# HISTORIC LANDMARK COMMISSION MAY 21, 2018 PERMITS IN NATIONAL REGISTER HISTORIC DISTRICTS NRD-2018-0026 1803 PALMA PLAZA OLD WEST AUSTIN HISTORIC DISTRICT

## PROPOSAL

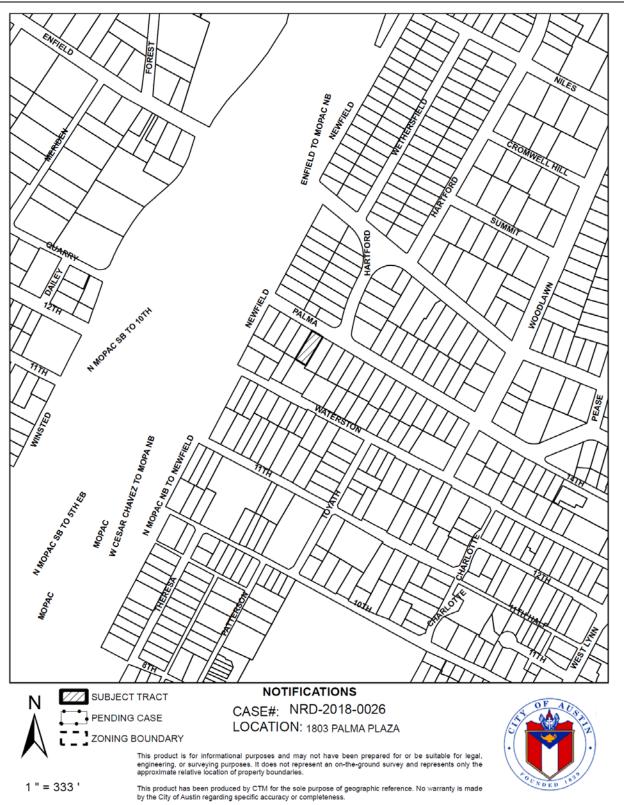
The proposed project will affect the historic character of this house; changing the door locations and windows will compromise the existing façade and the Tudor Revival stylistic influences on the architecture.

The rear addition is differentiated from the historic building due to its placement on the house, but the proposed changes to the façade present an issue in removing historic fabric, features, and spatial relationships between the curren bay openings.

The rear addition will require the removal of historic fabric and will impact the form and integrity of the house.

The proposed project does not comply with the applicable design principles and Secretary of the Interior' Standards. Completion of this project as proposed will likely render this house non-contributing to the historic district.

Comment on and release the permit, encouraging the applicant to retain and rehabilitate as many historic windows as possible, and to reconsider the reconfiguration of the facade. Staff further recommends the completion of a City of Austin Documentation Package, consisting of photographs of all elevations, a dimensioned sketch plan, and a narrative history, for archiving at the Austin History Center, prior to the release of any permits.
